Office Action Summary

10/534,178

BECK, JOSEF

DETAILED ACTION

FIG.1B

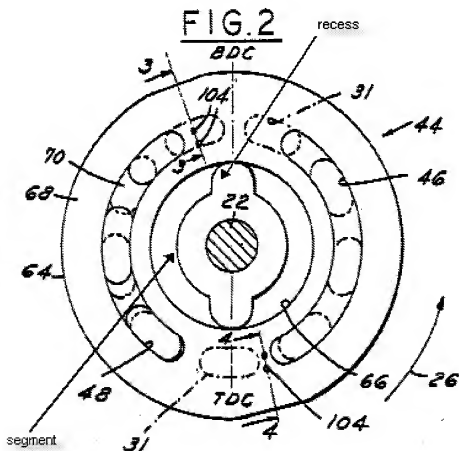
8. In Re claim 1, with reference to figures 1B and 2 depicted above, Tovey discloses a control plate (44) for an axial piston machine (12) having at least two control openings (46), (48) by means of which cylinder bores (30) of a cylinder drum (28) rotatably mounted (on shaft (22)) in housing (14) are alternately connected, on rotation of the cylinder drum (28), to a high pressure connection (48) and a low pressure connection (46) a through opening (66) formed in the control plate wherein:

10. In Re claim 4 and 12, Figure 1B of Tovey depicts a radial edge (lip that is pointed to by the arrow associated with label (44)). The lip surrounds the plate around the outer

13. In Re claim 8, with reference to figures 1B and 2 depicted above, Tovey discloses an axial piston machine (12) having a cylinder drum (28) which is rotatably mounted in a housing (14) and in which are made cylinder bores (30) in which pistons (32) are axially displaceably arranged, the cylinder bores (30) having openings (31) towards and end side of the cylinder drum (28) are alternately in connection with a high-pressure connection (48) and a low-pressure connection (46) via at least two control openings (46), (48) of a control plate (44), the control plate (44) having through opening (66) wherein:

14. In Re claim 10, Tovey discloses a cylinder drum (28) is mounted on a shaft (22), the shaft (22) being mounted in the housing (14) on the side of the control plate (44) by virtue of screw fastening (depicted in Figure 1A), and the control plate (44) is concentric with the shaft (22) which in turn is concentric with bearing race of roller bearing (24). The centering surface (segment) surrounds the shaft (22) and is also concentric.

16. In Re claim 13, Tovey depicts in Figure 1A that the interior of the control plate communicates with the space surrounding shaft (22) which further communicates with passageways (grooves) in the region on the side of the control plate facing away from the cylinder drum, the passageways further extending through elements (58) and (60) to passage leading back to the swash plate chamber (outside of the control plate) in the region of reference label "II" and "68", thereby connecting the inner volume to the outer volume.

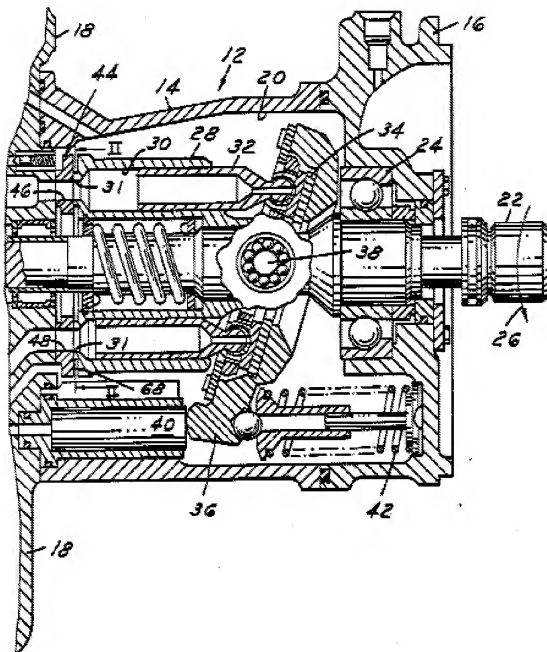
- the radially inner edge (depicted by label 66 pointer) of the control plate (44) is designed as a centering surface around shaft (22)
- the centering surface comprising plurality (2) of partial surfaces formed on segments (depicted above in Figure 2) of the inner edge of the control plate (44) which extend radially inward into the through opening (66) as depicted in Figure 2, and are separated by recesses as depicted
- both recesses are next to the centering surface (see figures in the "Response to arguments" section) and are capable of receiving a locking element.

9. In Re claim 3, Figure 2 of Tovey depicts the thickness of the segments is substantially the same as the depth of the recesses, and they also have a finite width. The recess transforms into a gap between the shaft (22) and the radially inner edge (depicted by label 66 pointer) after assembly of the machine.

11. In Re claim 6, Figure 2 of Tovey depicts the thickness of the segment is less than the thickness of majority of the plate.

12. In Re claim 7, Figure 2 of Tovey discloses kidney shaped control openings.

- the radially inner edge (depicted by label 66 pointer) of the control plate (44) is designed as a centering surface around shaft (22)
- the centering surface comprising plurality (2) of partial surfaces formed on segments (depicted above in Figure 2) of the inner edge of the control plate (44) which extend radially inward into the through opening (66) as depicted in Figure 2, and are separated by recesses as depicted

15. In Re claim 11, the radial extend of the recess is greater than the radial extend of the segment as depicted in Figure 2 of Tovey.

17. In Re claim 14, Tovey depicts the disc shape of the control plate in Figure 2, therefore the end side of the cylinder drum would also have to be disc shaped because the end side of the cylinder makes full surface contact with the control plate.

FIG. 4

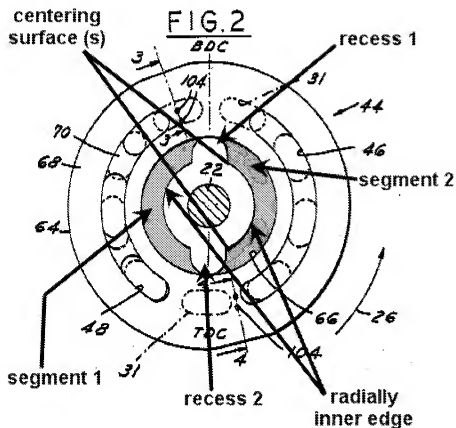
23. In Re claim 1 and 8, Tovey discloses all the claimed limitations except it does not explicitly disclose a centering body formed on the housing which is abutted against by the centering surface of the control plate

24. Nevertheless, Borcherdig et al discloses a control plate (32) which seats against the surface (14) of the housing cover. The plate having radial inner edges (26) with a surface that is a centering surface as stated in Column 1, Line 11: "...plurality of radially extending tabs centered in gaps in the peripheral edge". The inner edges (26) abut against a bearing (20) that is on the housing seat (22).

25. It would have been obvious to a person having ordinary skill in the art at the time of the invention to modify the port plate assembly of Tovey to incorporate the bearing (on the housing seat) into the central opening in the control plate that surrounds the shaft (the bearing could be the element surrounding the shaft that is not part of the control plate) where the radially inner edge abuts the bearing as taught by Borcherdig et al as a suitable design choice that supports a rotating shaft as stated in Column 1, Line 25 of Borcherdig et al.

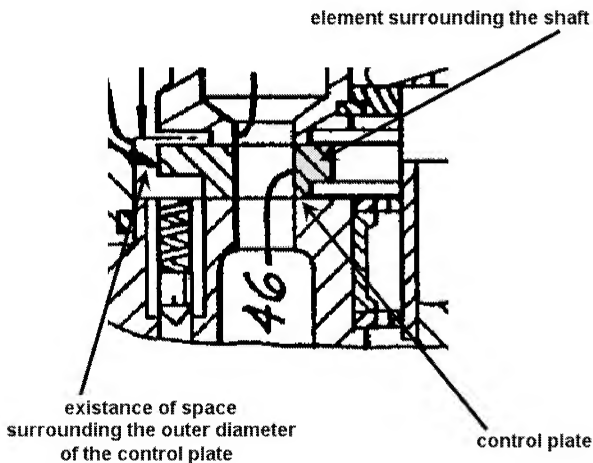
- Figure 2 of Tovey is a cross section of the apparatus, and the centering surface is perpendicular to the plane of this cross section which is why it is not visible in this view even though the radially inner edge is visible. Figure 2 of Tovey has been additionally annotated below.

Note the arcuate projection of the centering surface between ends of the two label lines, once again the centering surface is perpendicular to the plane of the figure. The shaded part of the figure is a protrusion that is part of the control plate.

- Tovey discloses at least 2 partial surfaces, one of which is annotated above on segment 2, the other is symmetrically on the opposite segment 1.
- With reference to the element surrounding the shaft not being part of the control plate, see annotated blowup of Figure 1B below.

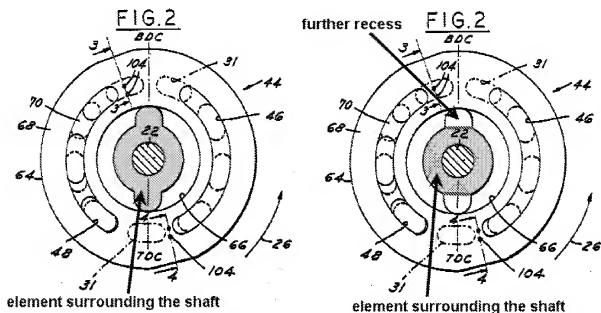
As seen by the crossing section lines, the element surrounding the shaft is part of the control plate and therefore there is no "separate" member interconnecting the control plate with a centering body.

The element surrounding the shaft (which mates with the centering surface) probably is separate from the shaft and looks like one of the two configurations depicted below by the shaded portion:

In the Figure on the left, the element surrounding the shaft would have to be fixed to the housing otherwise the projections will make the control plate rotate. In the Figure on the right, there is a further recess (at the centering surface) to receive a separate locking element.

- The above blowup depiction of Figure 1B also suggests that due to the existence of the gap around the outside diameter of the control plate, the control plate is not centered at its outer circumference.
